**AMENDMENTS TO THE DRAWINGS**

### **REMARKS**

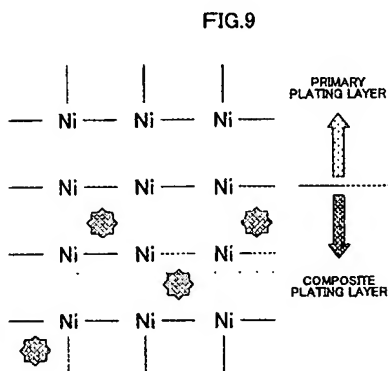
Murata relates to a stamper for molding an optical disk. The Office Action points to FIG. 5M as disclosing the claimed invention. Applicants respectfully disagree. First, if the Office Action is relying on all of layers 31, 36, 33 and 34 as disclosing the claimed stamper, then it does not have the claimed "pattern on a surface thereof for use in molding an optical disc substrate." As can be seen from the figure, FIG. 5M includes *both* the mother portion 31 and the heat insulated stamper 21 (FIG. 5N). Thus, the heat insulating stamper 21 of Murata would more accurately correspond to the claimed heat insulating stamper. If Murata is interpreted in this manner, then there is no "middle section" which includes the "same metal material as the uppermost and lowermost sections" and "heat insulating portions dispersed in the metal material of the middle section."

**FIG. 1**  
PRIOR ART

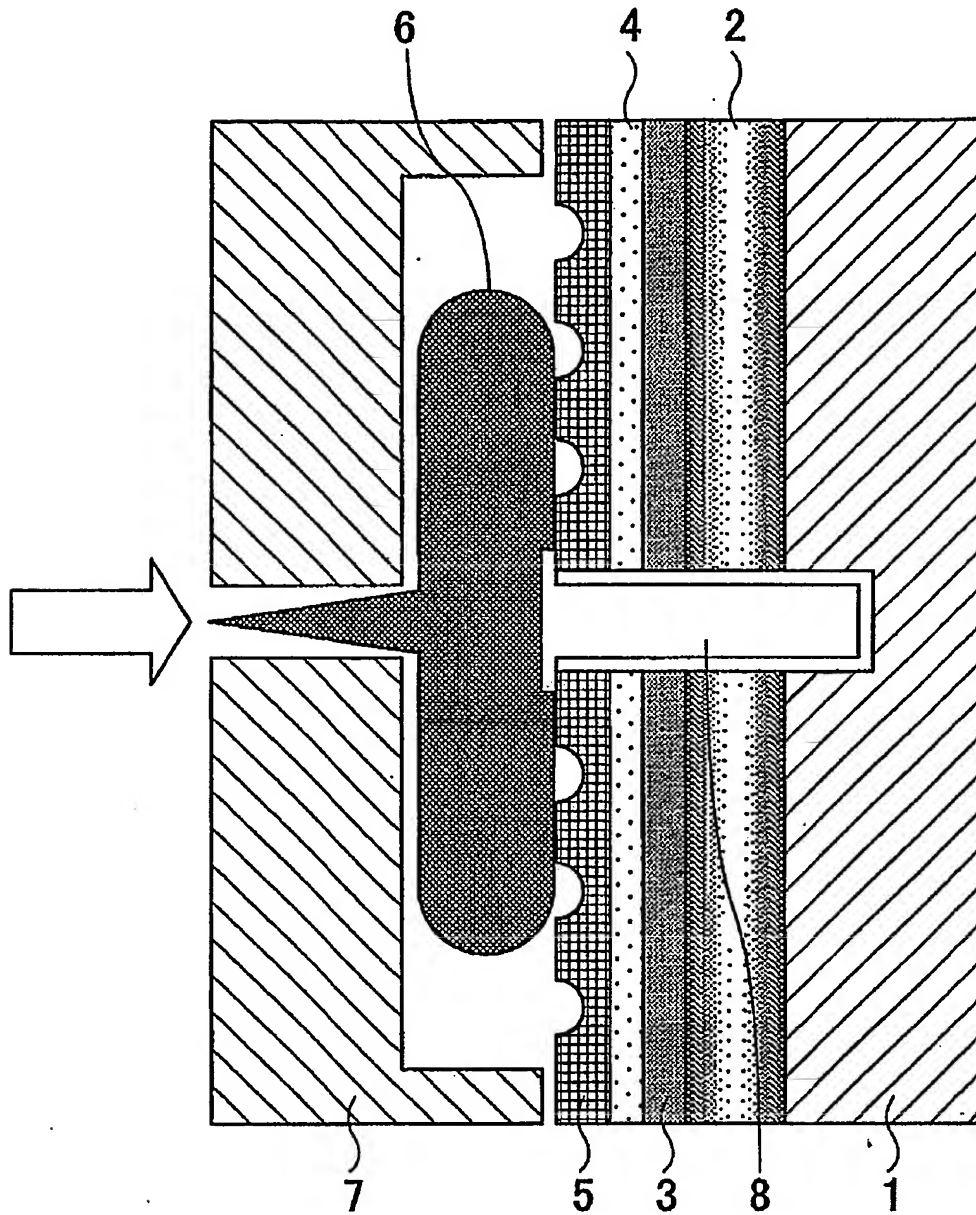
Figures 1, 2, 6 and 8 are objected to. Figures 1, 2, 6 and 8 have been amended to be designated as "Prior Art." As such, Applicants respectfully submit that the figures are in condition for allowance and request that the objection be withdrawn.

The attached sheet(s) of drawings includes changes to FIGS. 1, 2, 6 and 8.
